**Broad Development Parameters of the Indicative
Development Proposal in Respect of Application No. Y/YL-LFS/14**
关于申请编号 Y/YL-LFS/14 而只作指示用途的拟议发展计划的概括发展规范

Application for Amendment of Plan Under Section 12A of the Town Planning Ordinance (Cap.131) for Proposed Residential Development and Social Welfare Facility (Child Care Centre) at Various Lots in D.D. 128 and D.D. 129, and Adjoining Government Land, Lau Fau Shan, Yuen Long, New Territories (Planning Application No. Y/YL-LFS/14)

Application for Amendment of Plan Under Section 12A of the Town Planning Ordinance (Cap.131) for Proposed Residential Development and Social Welfare Facility (Child Care Centre) at Various Lots in D.D. 128 and D.D. 129, and Adjoining Government Land, Lau Fau Shan, Yuen Long, New Territories
 (Planning Application No. Y/YL-LFS/14)
Responses to Comments

INDICATIVE BASEMENT PLAN (B2)

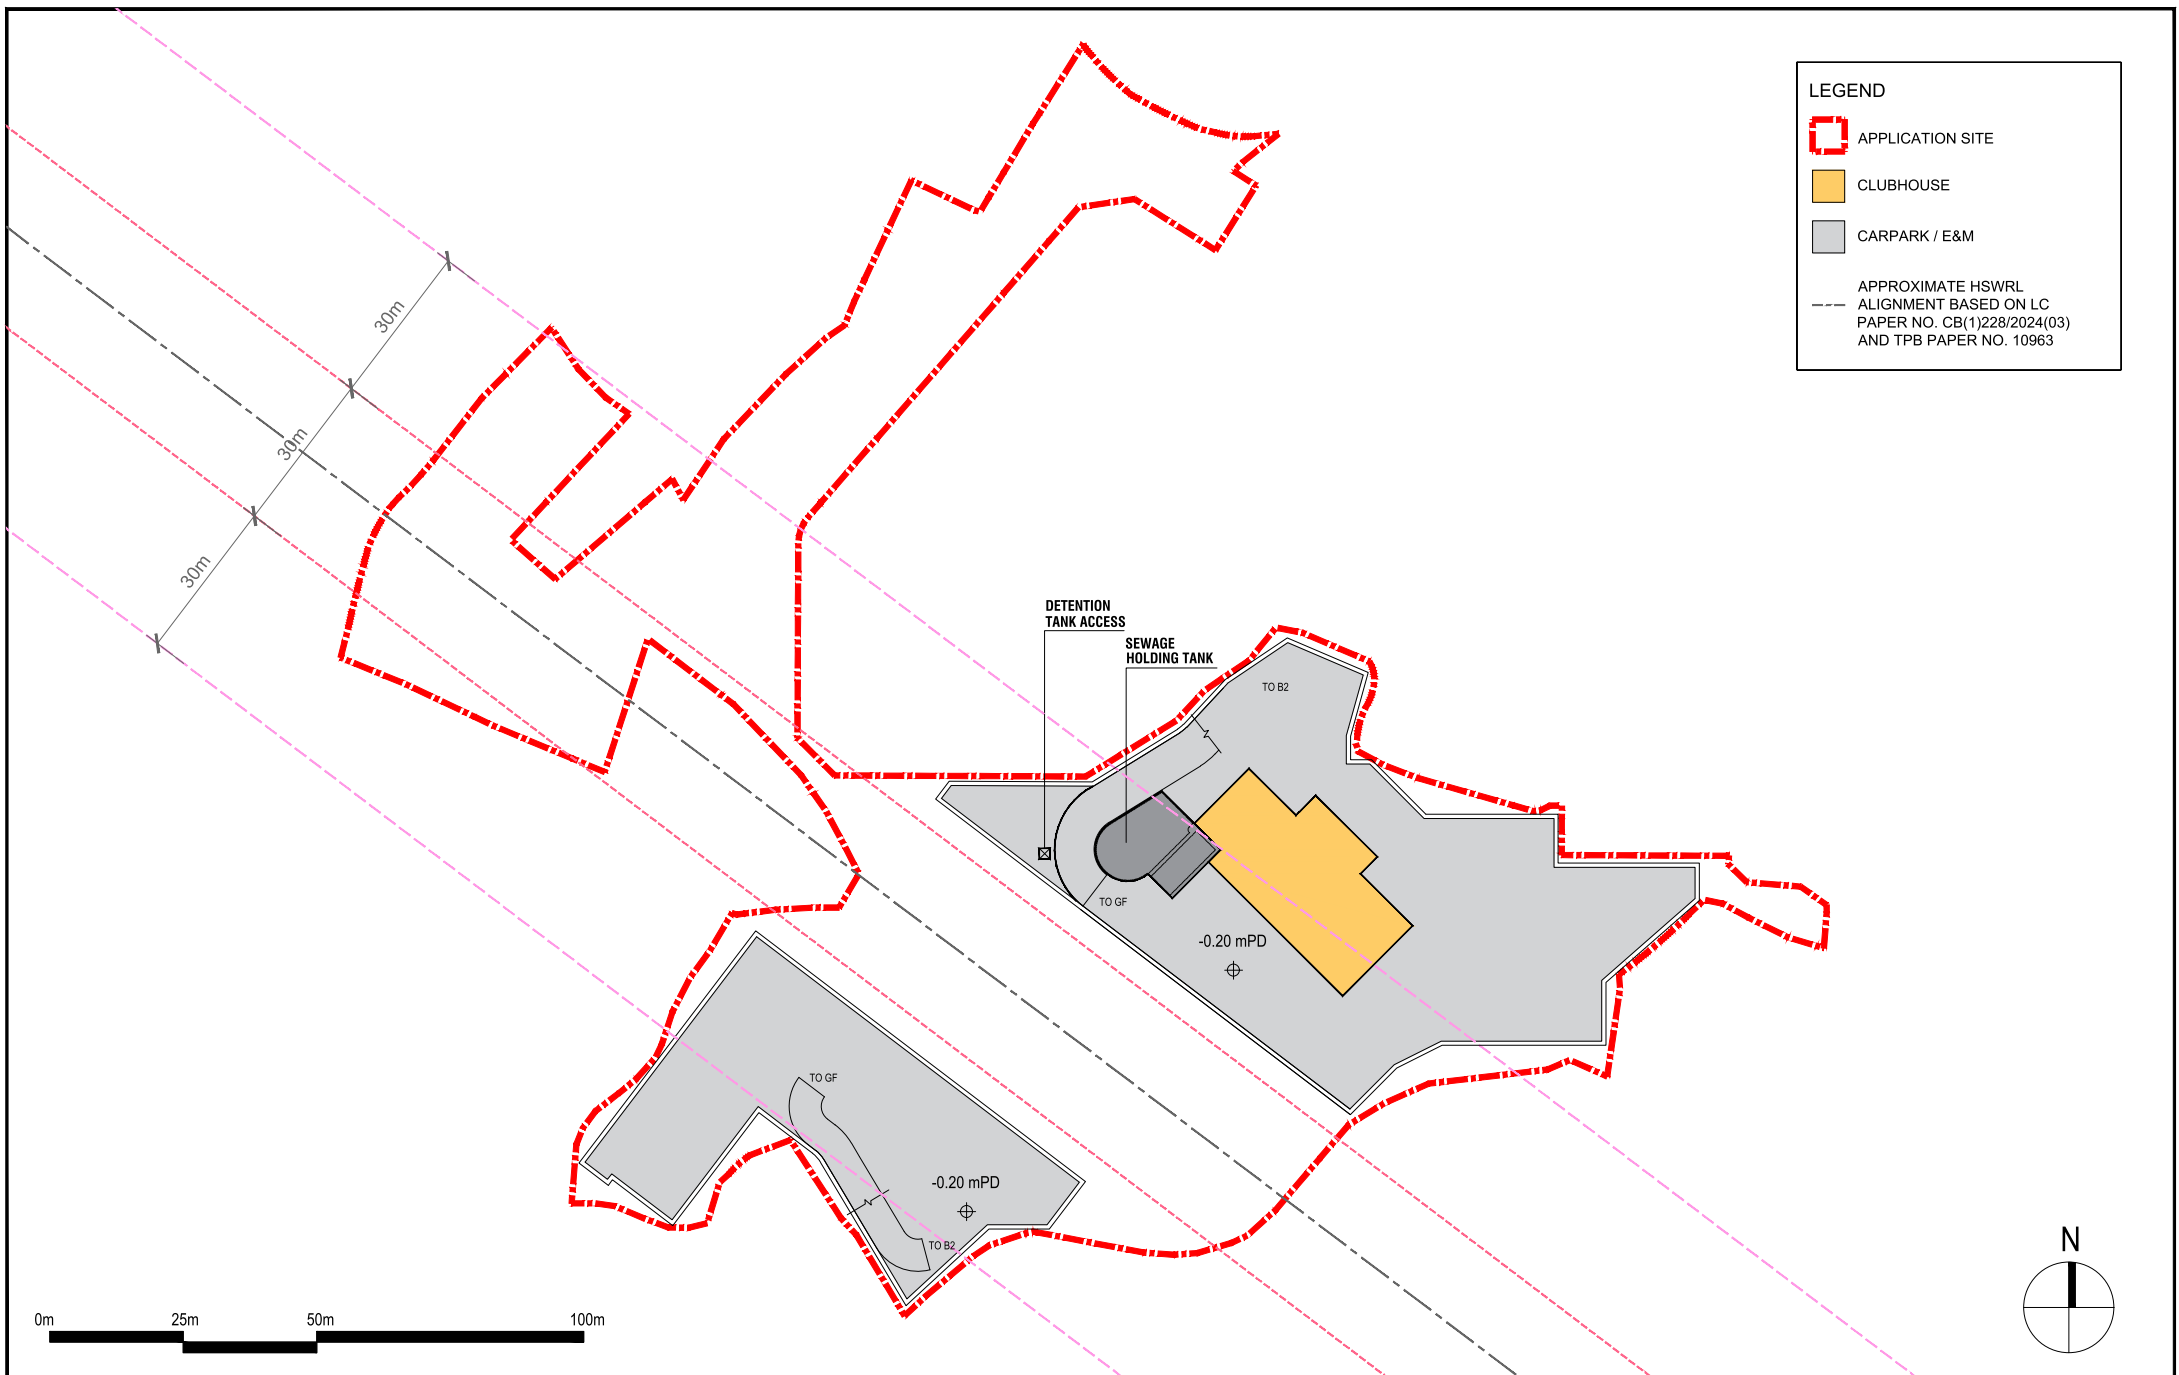
No.	Comments	Responses
	<p>development including any odour detected at the site boundary of Lau Fau Shan SPS.</p> <p>8. Section 2.4.9: Please obtain an updated complaint record for Lau Fau Shan SPS covering more recent years.</p> <p>9. Site surveys shall be conducted to verify whether any odour nuisance arises from the Deep Bay Grove RCP, which is located approximately 30 m upwind from the proposed development site.</p> <p>10. Section 2.5: - Please consider adding "avoid using exempted NRMMS" as a mitigation measure, given that several ASRs are located within close proximity (less than 10 meters) to the construction site. - Owing to the large project site area and the close proximity of ASRs, phasing of the dusty activities shall be implemented and a dust monitoring program is highly recommended during the construction phase.</p> <p>11. Section 2.5.1: Please remove "dust" in line 8.</p> <p>12. Section 2.6.1: Please revise "dust impact" in line 3 to "air quality impact".</p> <p>13. Section 5.1.2: Please add "nearby ASRs and" before "proposed development" in line 6.</p> <p>14. Please indicate on a map the locations of exhaust outlets for carparks, the sewage-related facilities and the refuse collection points. During the operation phase of the proposed development, the Applicant must adhere to relevant guidelines to ensure that these facilities do not create air and odor nuisances or impacts for the air-sensitive uses of the proposed development, or for any air-sensitive uses within the 500 m assessment area. Any exhaust outlets from these facilities should be situated away from any ASRs in the vicinity.</p>	<p>Development and at the Lau Fau Shan SPS. Survey dates in Sections 2.4.9 and 2.4.10 of Annex C have been updated.</p> <p>DSD's updated record for Lau Fau Shan SPS has been added to Appendix 2.1 of Annex C.</p> <p>An updated site survey was conducted on 12 September 2023. No odour was detected near the Deep Bay Grove RCP.</p> <p>Section 2.5 of Annex C has been supplemented to add "avoid using exempted NRMMS" as a mitigation measure.</p> <p>Section 2.4.2 of Annex C has been supplemented to recommend phasing of dusty activities and a dust monitoring program.</p> <p>Section 2.5.1 of Annex C has been revised accordingly.</p> <p>Section 2.6.1 of Annex C has been revised accordingly.</p> <p>Section 5.1.2 of Annex C has been supplemented accordingly.</p> <p>Figure 2.1 of Annex C has been supplemented to show the indicative locations of exhaust outlets from these facilities to situate away from ASRs in the vicinity as far as possible. As such, the layout of the Indicative Baseline Plan (B2) has been revised.</p>

Figure: 2.1

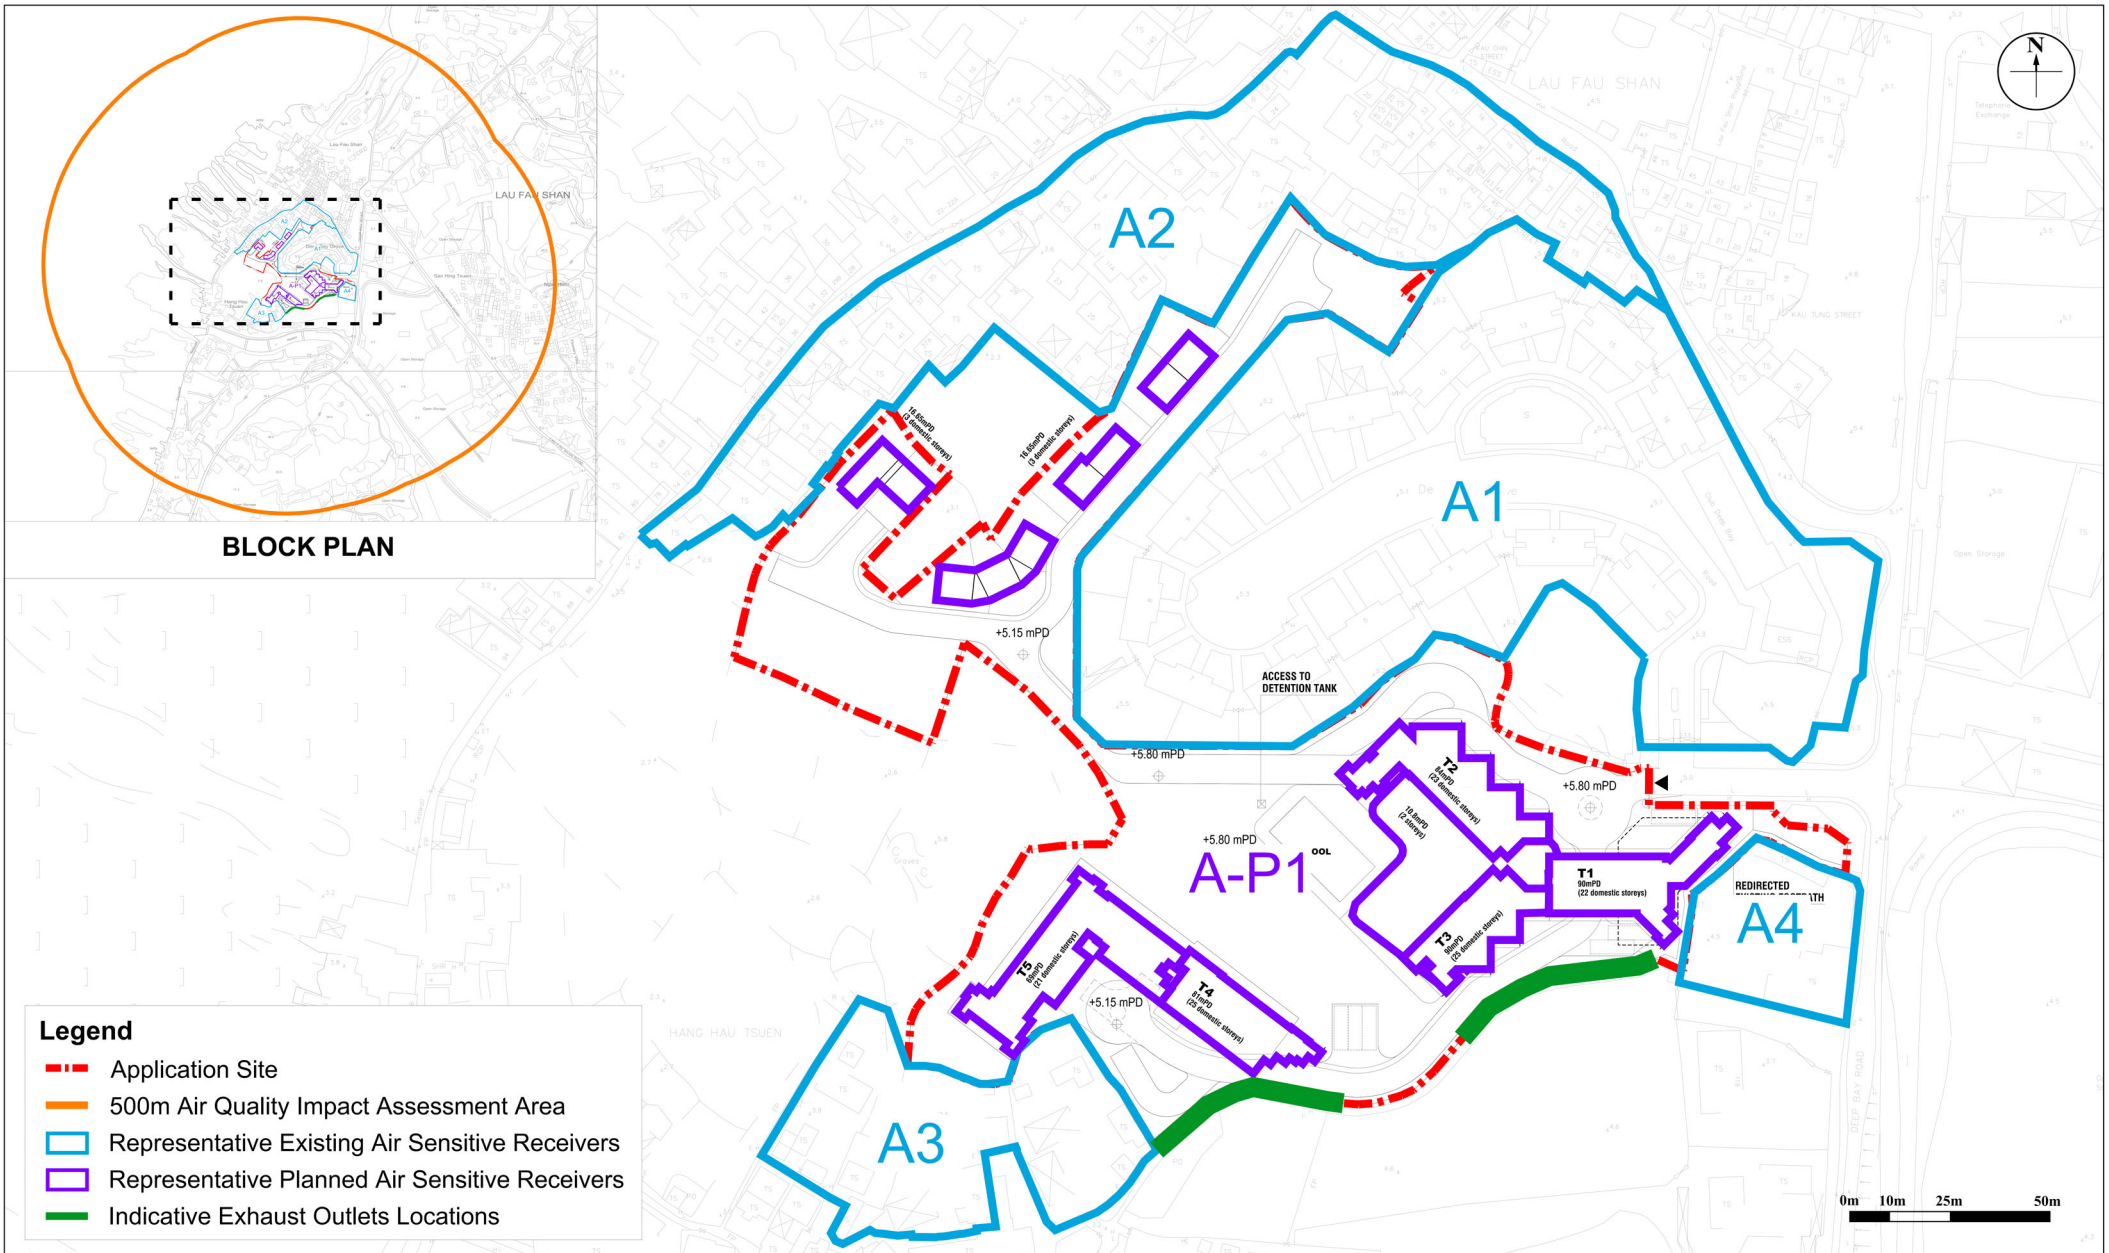
No.	Comments	Responses
	<ol style="list-style-type: none"> 1. Table 2.2 and Figure 2.1: In addition to the residential towers, the club house and the 2 clusters of houses shall also be included as planned ASRs. 2. Section 2.4.2: Please provide the excavation area and the amount of excavated materials to be handled to justify that the scale of work is small. 3. Section 2.4.3: Please provide the number of construction trucks and mechanical equipment to be used per time over the work site to justify that the number of construction plant required on-site is limited. 4. Please clarify whether there are any concurrent projects within the 500 m assessment area and whether cumulative air quality impact shall be assessed. 	<p>Table 2.2 and Figure 2.1 of the replacement pages of the Environmental Assessment (Annex C) have been revised to supplement the club house and the 2 clusters of houses as planned ASRs.</p> <p>It is estimated that the area of excavation is about 8,489 m², and the amount of excavated material to be handled is around 400 m³ per day. Section 2.4.2 of Annex C has been supplemented to provide such information.</p> <p>As the project is still in early planning stage, detailed construction information is not available at this stage. Section 2.4.3 of Annex C has been revised to avoid confusion.</p> <p>No, there are no concurrent projects within the 500m assessment area of the Proposed Development. Although the site formation and engineering infrastructure works of HSK/HT NDA Second Phase development is planned to commence in 2024 for completion by 2030, its works boundary is outside the Proposed Development's 500m assessment area (see extract of LC Paper No. CB(1)48/2024(03)). The programme of the remaining phase development is uncertain yet. Hence, adverse cumulative air quality impact is not anticipated.</p>

Figure: 2.2

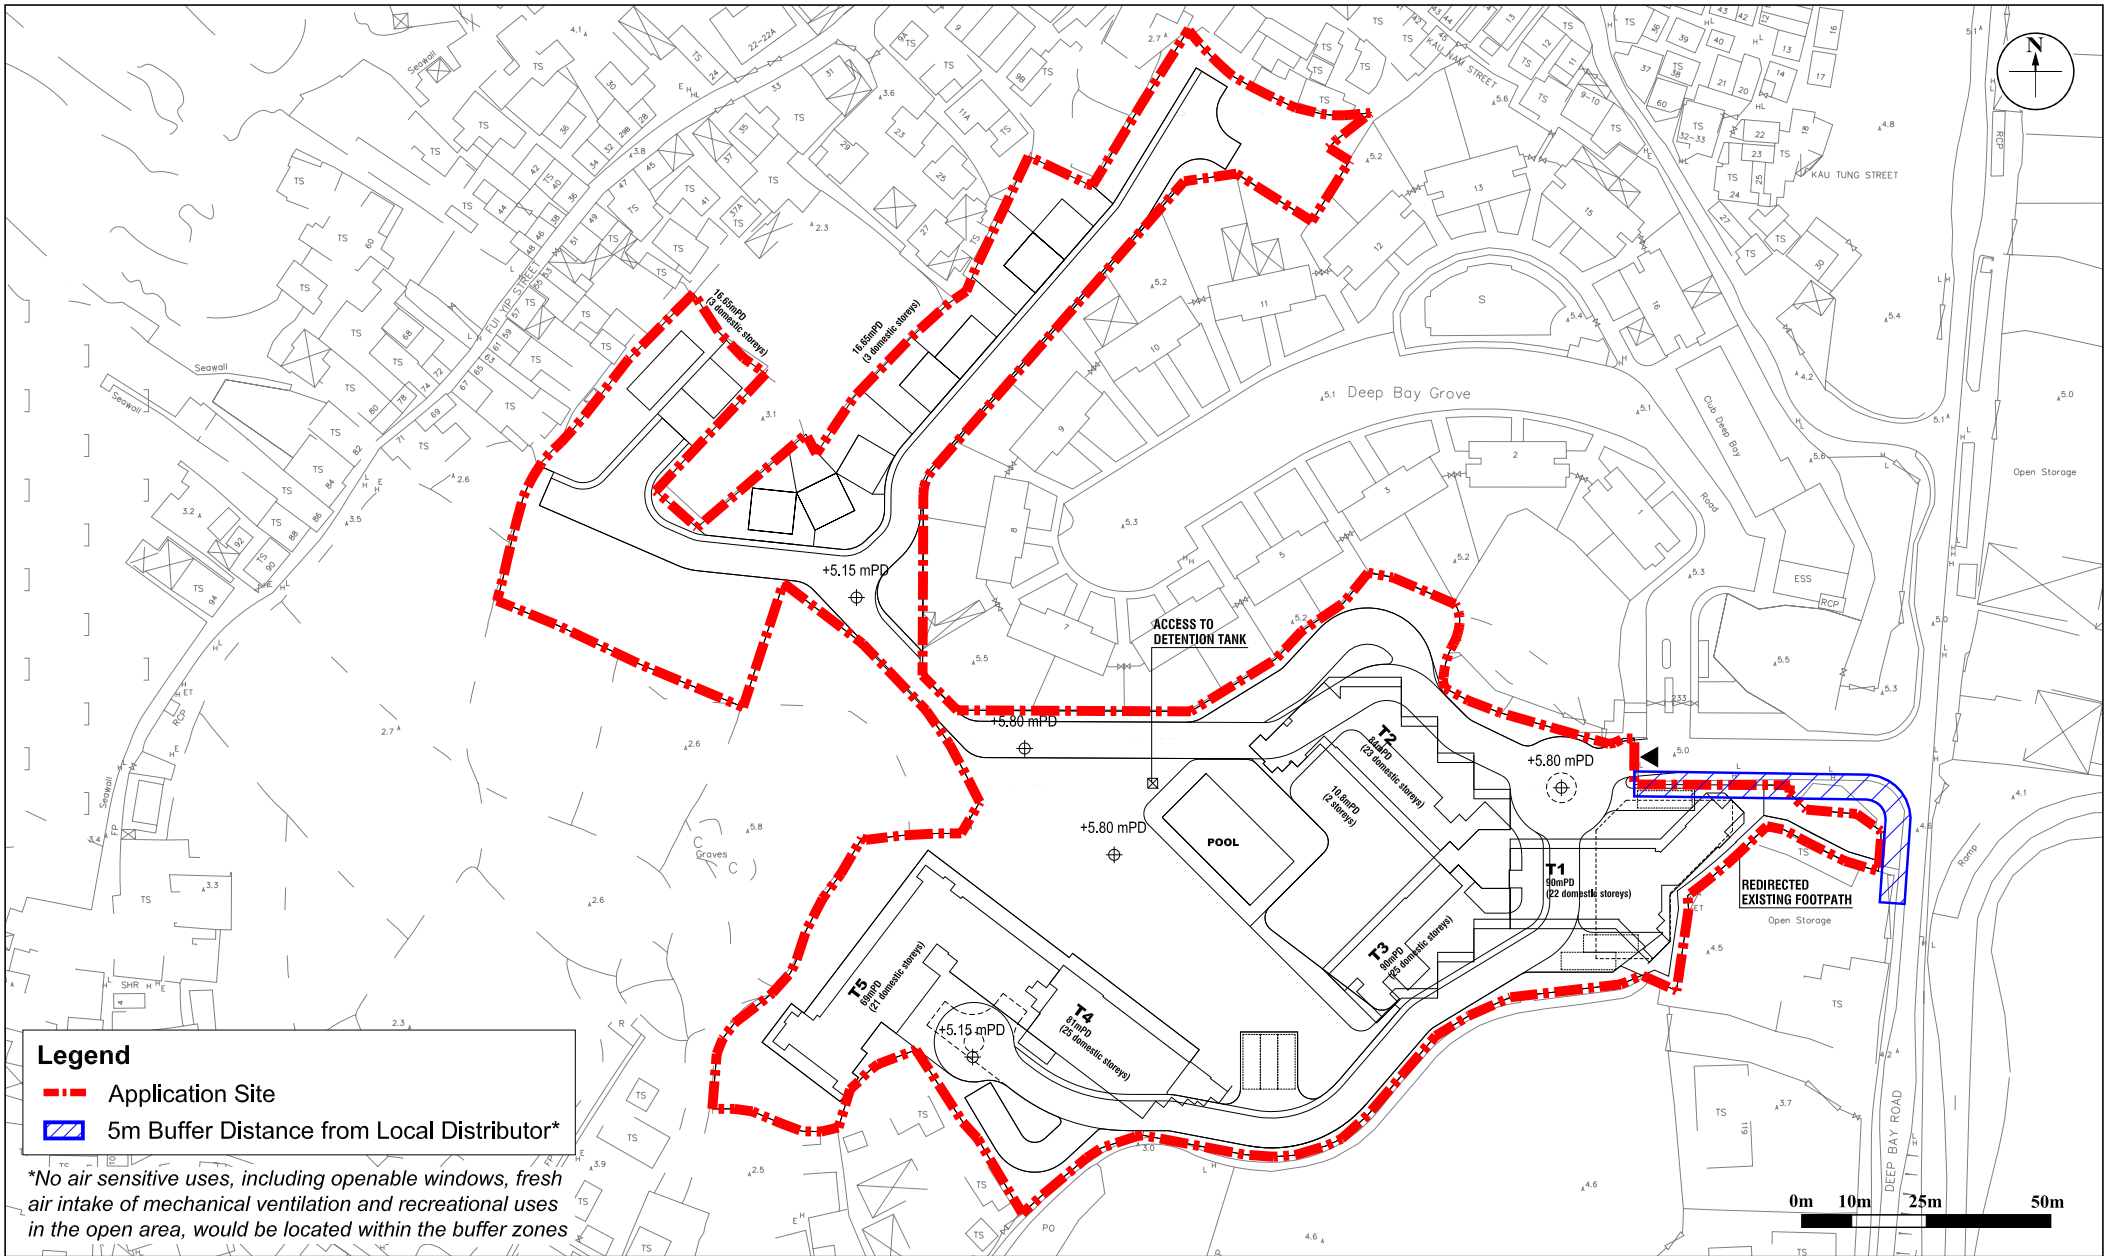
No.	Comments	Responses
	<p>15. Figure 2.2:</p> <ul style="list-style-type: none"> - Please add a remark to state that "no air sensitive uses, including openable windows, fresh air intake of mechanical ventilation and recreational uses in the open area, would be located within the buffer zones". - Please delete "Rural Road/" in the legend. 	<p>Figure 2.2 of Annex C has been supplemented and revised accordingly.</p>
<p>3.</p>	<p>Environmental Protection Department, Environmental Assessment Division, Territory North Group, Yuen Long, dated 12 June 2024</p> <p><u>Noise</u></p> <p>It is noted that the applicant submitted FI involving substantial changes to the indicative development scheme. According to the updated EA, the predicted traffic noise and fixed noise would comply with the noise criteria and requirements under HKPSG and NCO. Given practicable and feasible noise mitigation measures could be available, from noise planning point of view, we shall maintain <u>no objection</u> to this planning application provided that there is a mechanism, e.g. lease condition, to require the applicant to submit a proper NIA report to review, explore, demonstrate and implement noise mitigation measures for full compliance with the relevant noise criteria and requirements under ProPECC PNs, HKPSG and NCO. The following <u>advisory suggestions</u> are provided to the applicant/consultant to facilitate the integrity and appropriateness of their future submission, if any, as appropriate.</p> <ul style="list-style-type: none"> • S.4.3 & S.4.7 - Given fixed noises is controlled under NCO, to prevent NCO implication and also for avoidance of doubt, a new paragraph should be added after S.4.3.4 as "To ensure the fixed plant noise generated by the Proposed Development would not cause excessive impact to nearby noise sensitive receivers, potential fixed noise sources within the Proposed Development shall be properly designed to meet the relevant noise criteria as stipulated in Chapter 9 of the HKPSG and NCO. 	<p>S.4.3.5 of Annex C has been supplemented to avoid confusion.</p>

- 2.4.7 Building setback of more than 5m from road kerb of the access road and Deep Bay Road has been incorporated into the design of the proposed development (**Figure 2.2** refers). No air sensitive uses, including openable windows, fresh air intake of mechanical ventilation and recreational uses in the open area, shall be located within the 5m buffer zone. As the Application Site has incorporated adequate setback distance and can satisfy the above-mentioned buffer distance requirement in HKPSG, no adverse air quality impact is therefore anticipated.
